# **FINAL DRAINAGE REPORT**

## **WALDEN PRESERVE 2 – FILING NO. 4**

**JPS Project No. 040201**

Add "PCD File No. SF-18-034"

SHEET: **D1**

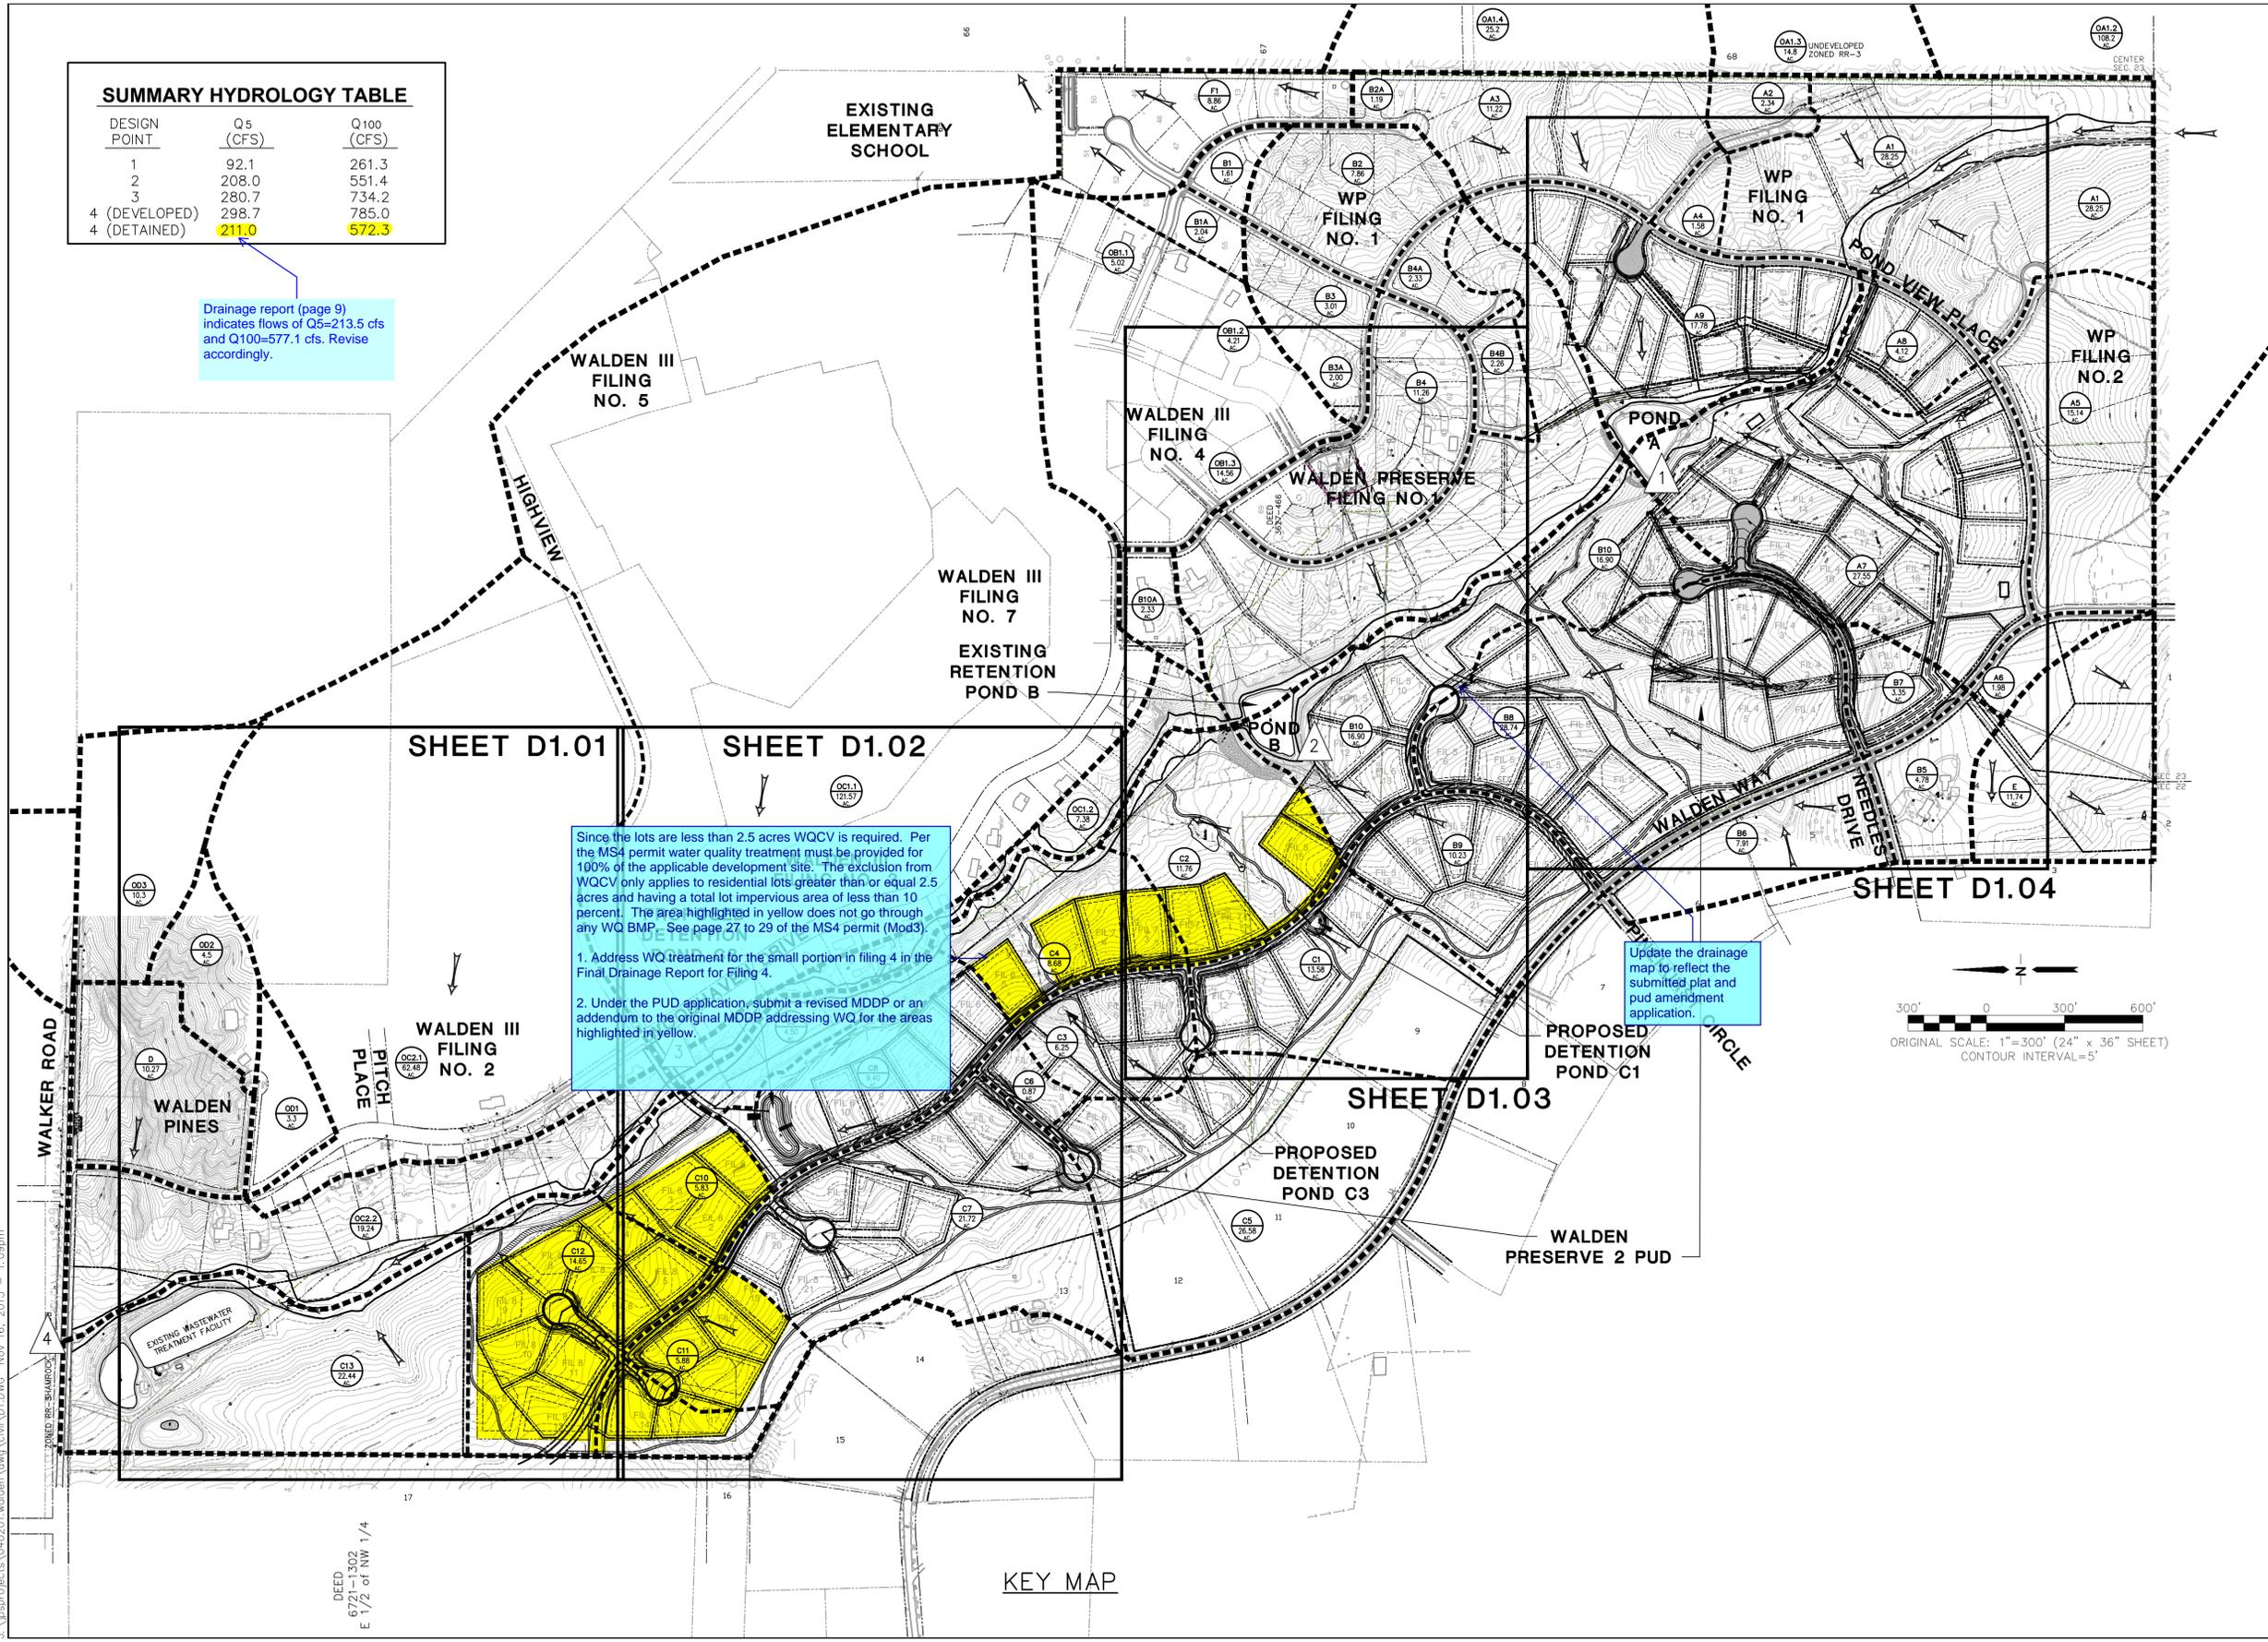
Drainage report (page 9) indicates flows of Q5=213.5 cfs and Q100=577.1 cfs. Revise accordingly.

1. Address WQ treatment for the small portion in filing 4 in the Final Drainage Report for Filing 4.
2. Under the PUD application, submit a revised MDDP or an addendum to the original MDDP addressing WQ for the areas highlighted in yellow.

Update the drainage map to reflect the submitted plat and pud amendment application.

SHEET: D1.03

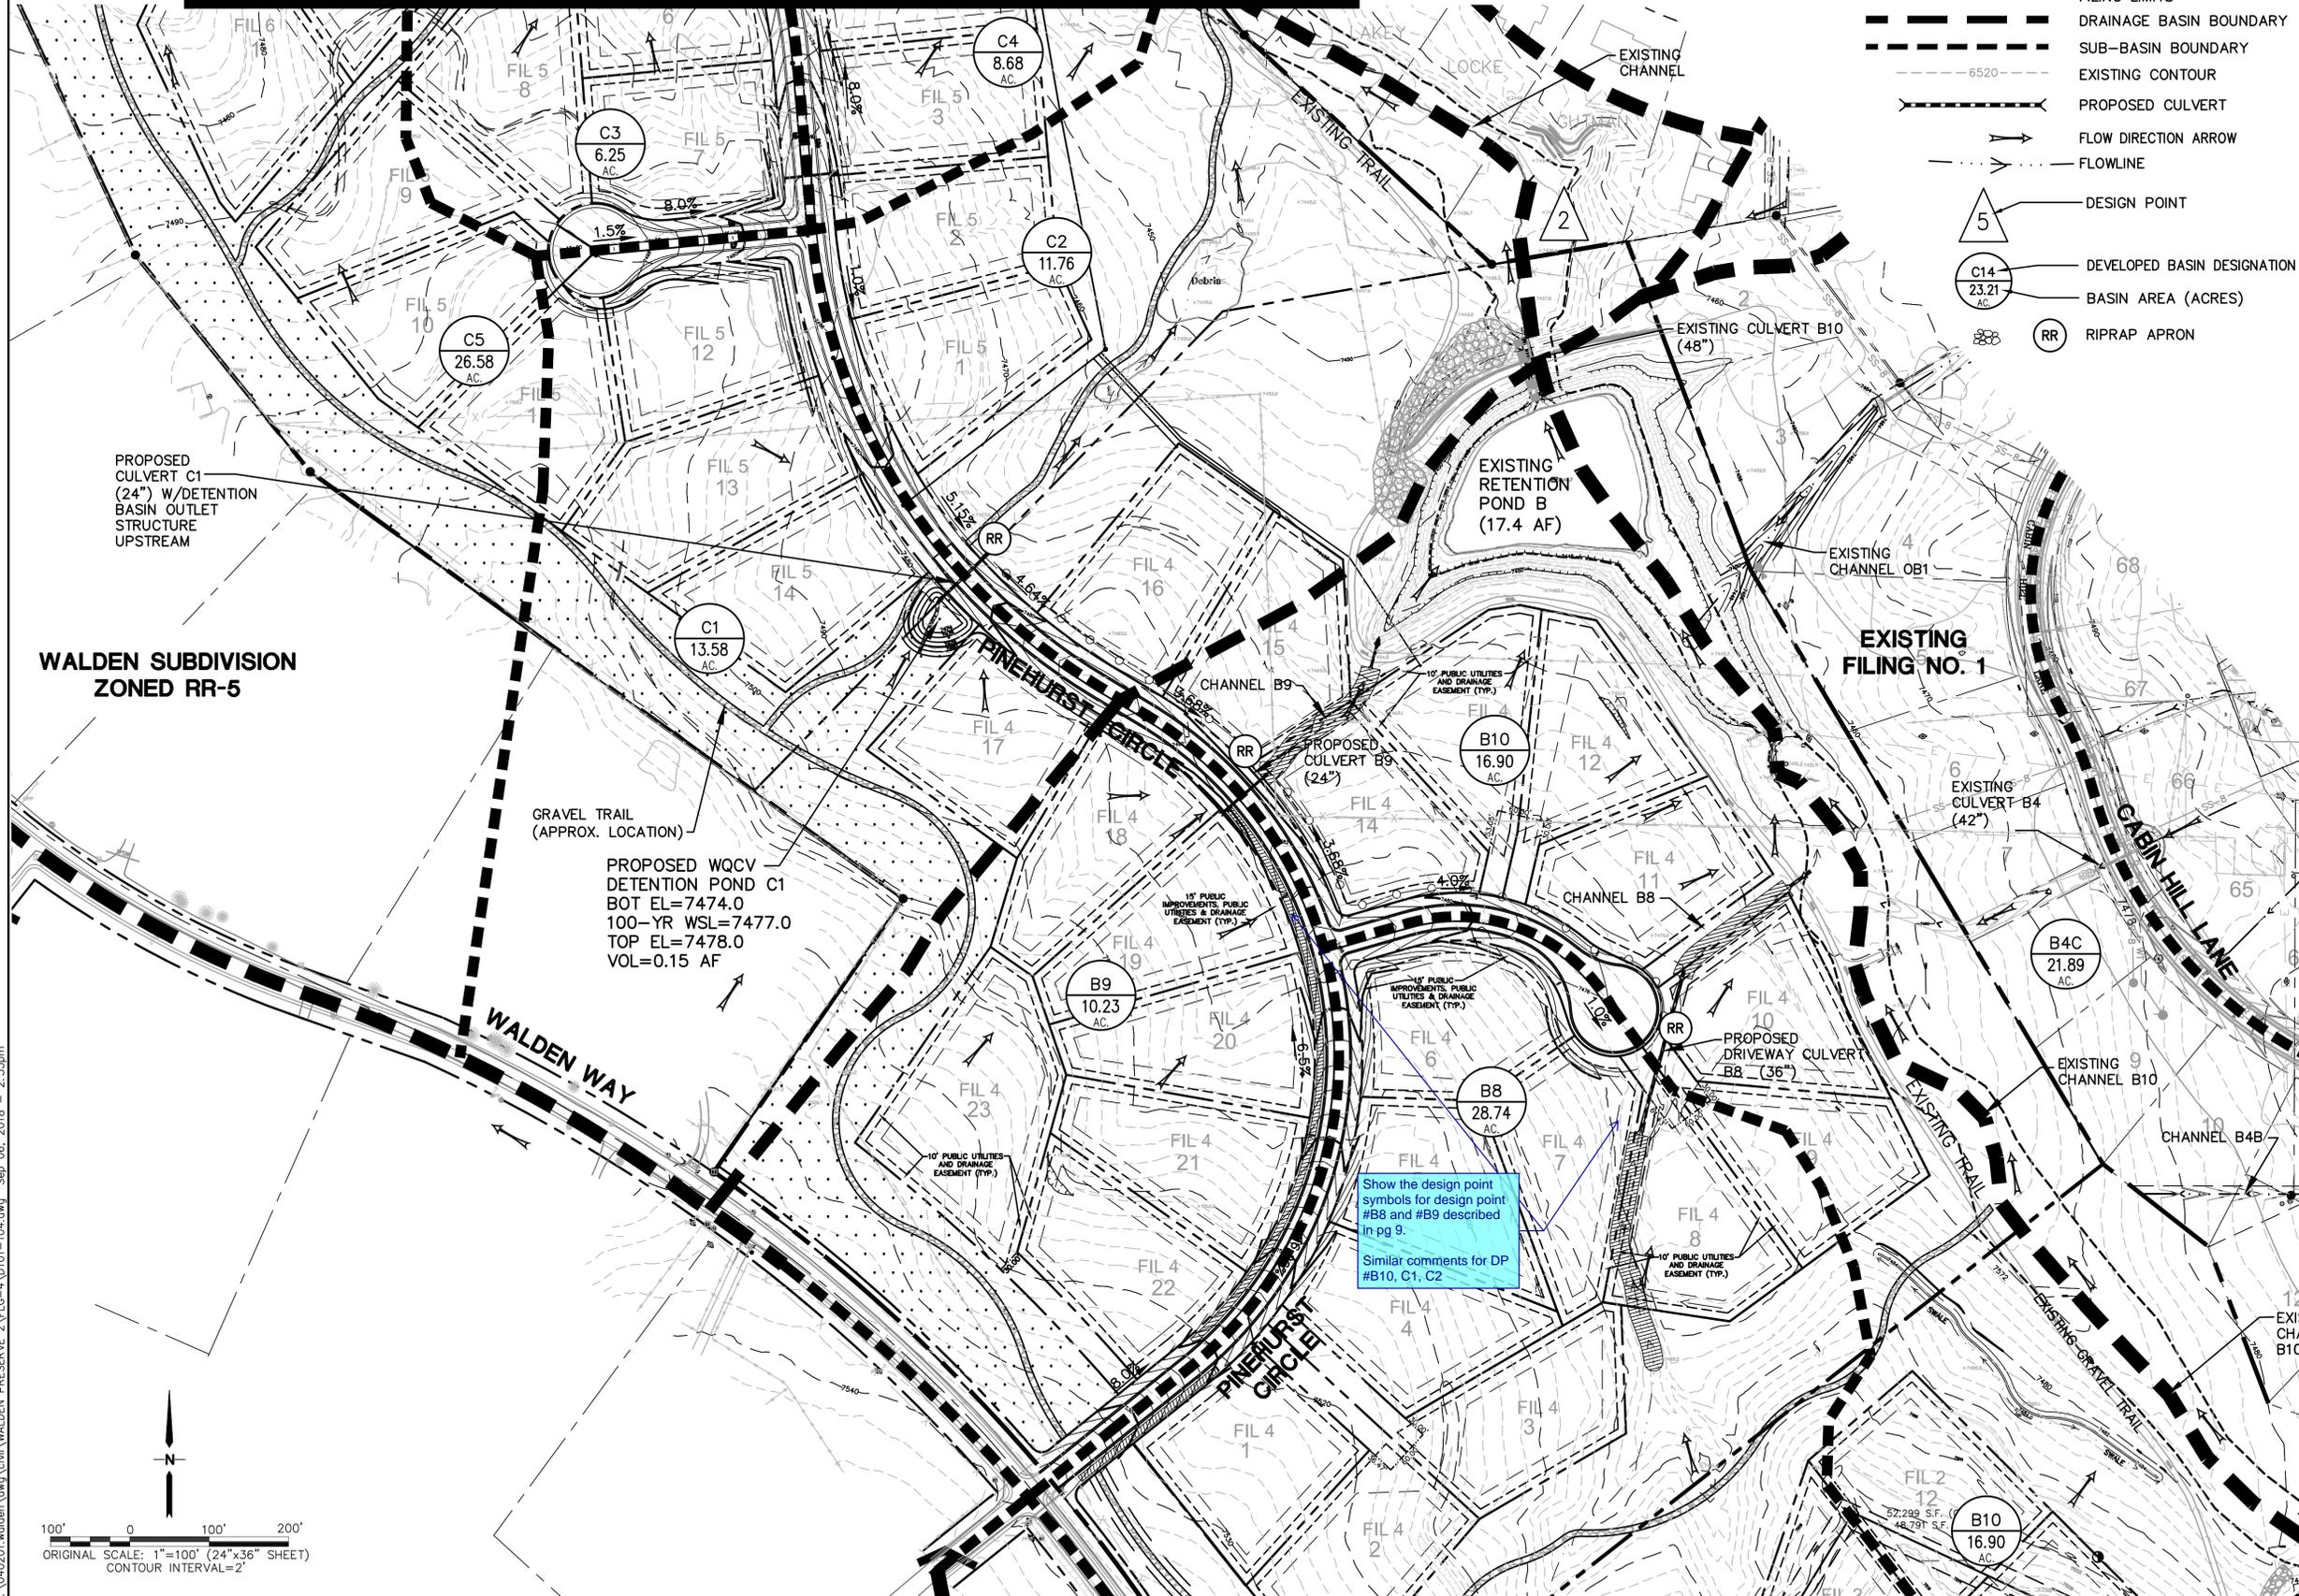
Show the design point symbols for design point #B8 and #B9 described in pg 9.  
 Similar comments for DP #B10, C1, C2
